COLLECTION OF CTL DECISIONS

1.1.1.1 Standard:	1.1.1.2 Sub clause:	**Sheet n. 364**
IEC 61010-1:1990 +A1:1992 + A2 :1995	*6.6.2*	**Page 1(1)**
1.1.1.3 Subject:	**Key words:**	**Provisional decision taken by ETF3 and confirmed by CTL at its 38th meeting, in Toronto**
Terminals for external circuits	- 4mm plugs - CAT III (300V) - CAT II (600V)

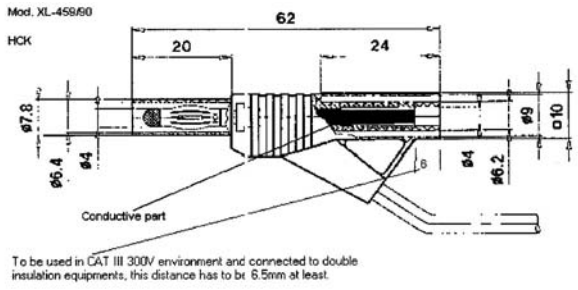
For CAT III (300V) or CAT II (600V) a distance between Live metal parts and accessible parts should be 6.5 mm. In practice with touch-safe 4mm plugs this distance is not maintained (mostly 6 mm, see drawing attached). How do test houses deal with this?

Where test leads are provide as part of equipment under test then the leads must also comply with IEC61010. If test leads are not part of the equipment under test then the user handbook must say that the leads to be connected to the equipment shall also comply with IEC61010 requirements, i.e. 6.5mm requirement shall be met.
